PLAN AND ZONING COMMISSION

Case F20-05 & P20-1 of IMEG for final (and preliminary) plat KC Kimberly Hills Addition on 8.57 acres, being a replat of lot 2 of Westgate 13th Addition (PIN 01637-02) located north of the W 37th St & N. Birchwood Ave intersection; plat to contain 33 single-family lots. [Ward 2]

Plat

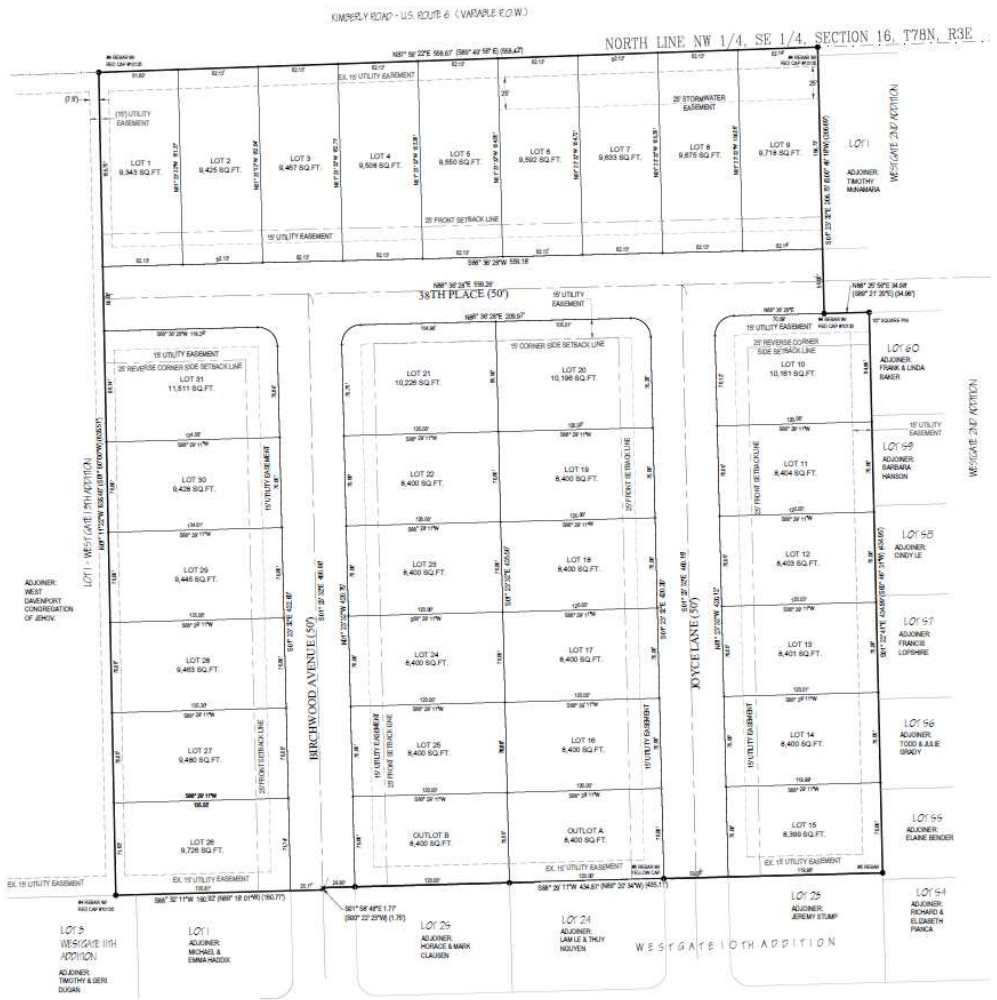
1. Kimberly Street shall be changed to "Kimberly Road"
2. A permanent or temporary turn around, either with a hammer head or cul-de-sac at the west end of 38th, shall be proved for city services;
3. Storm sewer, excess stormwater passageway and sanitary easements shall be shown;
4. The outlots shall be labeled according to their purpose;
5. Existing sewers shall be identified;
6. Sanitary sewer shall be shown in correct location within the utility easement and the description shall include sewer in the easement description

1. Monuments shall be described and shall have a tie to quarter sections;
2. A sanitary easement shall be provided;
3. Storm sewer and excess stormwater passageway easements shall be shown;
4. The purpose and maintenance responsibility of the outlots shall be shown/noted;
5. ROW shall be called out to be dedicated with the recording of the plat;
6. Sidewalk along Kimberly Road shall be constructed with sidewalk along 38th Place and shall be properly noted and the statement excluding the sidewalk in note 11 shall be removed;
7. Curve locations shall be identified on the plan;

8. Storm sewer easement for lots 6, 7, & 8 shall be accessible from a location other than Kimberly Road ROW, should the State disallow access from a state route;
9. Stormwater management shall be provided shall be provided for northerly flow; a stormwater easement is not sufficient.
10. Water quality treatment facilities shall be required and an easement for such" (either specific or blanket site easement) "shall be provided to allow access to and throughout the water quality best management practice site(s)
